Evaluation of proposed move for Water Right No. 39036

Proposed: Move water right no. 39036 to a new well location, a distance of 2,628 ft to the east. This water right was recently moved, so drawdown effects were calculated from the previous location.

Data Set: C:\Users\trevora\Documents\2023_moves\39036\39036 Current.aqt
 Date: 03/27/23 Time: 13:53:38

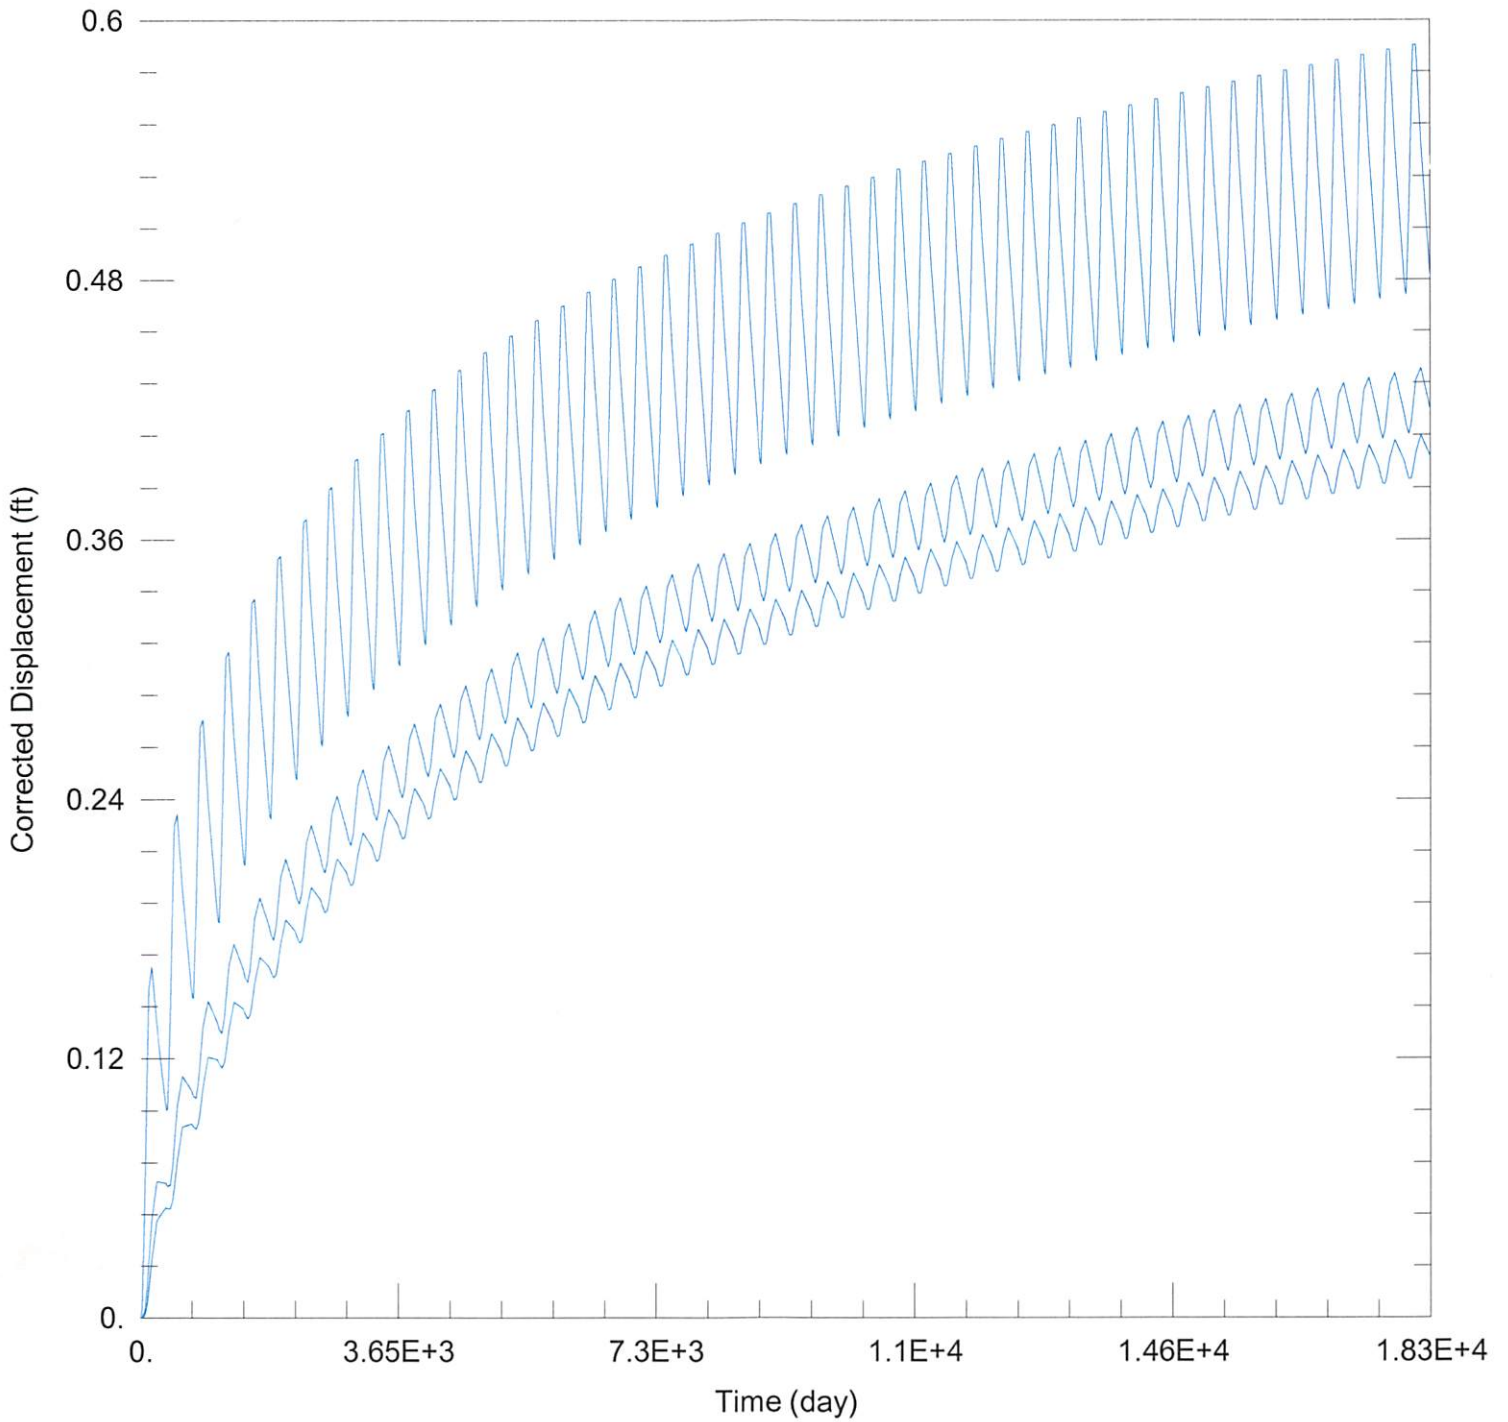
13630 & 19827:	Drawdown from current location = 0.59 ft
	Drawdown from proposed location = 2.41 ft
	Net drawdown = 1.8 ft
6230:	Drawdown from current location = 0.41 ft
	Drawdown from proposed location = 1.62 ft
	Net drawdown = 1.2 ft

Domestic 17-33-38: Drawdown from current location = 0.44 ft

Drawdown from proposed location = 1.67 ft

Net drawdown = 1.2 ft

Net drawdown does not exceed the drawdown allowance of 3.5 ft for any well within 1 mile of the proposed location. Therefore, critical well analysis is not necessary.
